Your ref.:
CDM Ref 2117

Response to request for review of the project “Heilongjiang Yilan Hezuolinchang Phase II Wind Power Project” (2117)

Figure 1 Trends for the tariff of the projects commenced after 2002 in Heilongjiang province

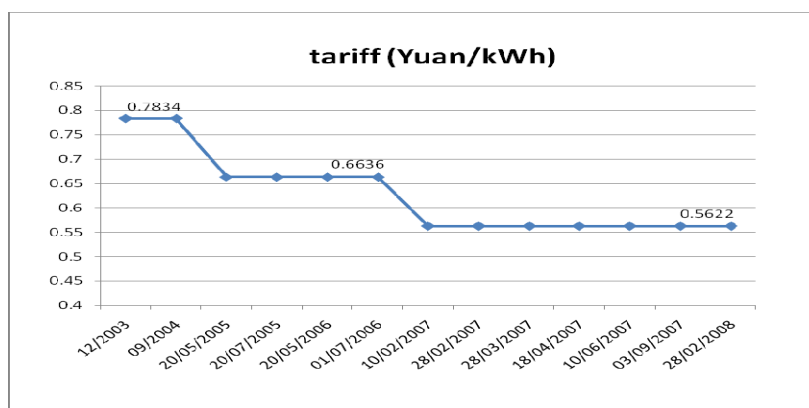
Comment 2: The DOE is requested to confirm the appropriateness of the electricity tariff assumed in the PDD, in comparison with previous tariff notifications for similar projects in the same region which commenced since 2002 and whether such information was available at the time the FSR was prepared.

In the Heilongjiang Province where the Heilongjiang Yilan Hezuolinchang Phase II Wind Power Project is located, the tariff trend from 12 other wind projects⁷ commencing after 2002 in Heilongjiang province is presented in the following diagram.

The below diagram shows that the tariff was decreasing from 0.7834 to 0.5622 Yuan/kWh (Excl.VAT), and the tariff of 0.5622 Yuan/kWh (Excl.VAT) was the prevailing tariff when the FSR of Heilongjiang Yilan Hezuolinchang Phase II Wind Power Project was finalized in January 2008.

Two periods can clearly be identified from the above diagram:

1) **Uncompetitive period:** A few wind farm projects developed this period were enjoying the benefited policy from more favourable tariff⁸ of 0.7843 Yuan/kWh (Excl.VAT) and were funded by international low interest loan⁹ or national soft loan¹⁰. The projects are demonstration projects of Heilongjiang Mulan Wind Power Project and Heilongjiang Fujin Wind Power Project. Therefore, the projects developed in this period can not be regarded as comparable projects to the proposed project.

2) **Competition initiated period:** The “Provisional Measures for the Administration of the Electricity On-Grid Tariffs” (“On-Grid Tariff Measures”, taking effect on 1 May 2005), aims to regulate the determination of the electricity tariff offered to power producers in order to stabilize tariffs and increase competitiveness in the electricity market.

After 1 May 2005 the observed decrease in the tariff has not substantially lowered the return on investment of wind farm projects in Heilongjiang Province as the market share of domestic equipment has increased. Such an equipment investment decrease is likely to counter the impact of lower tariffs on the return of investment.
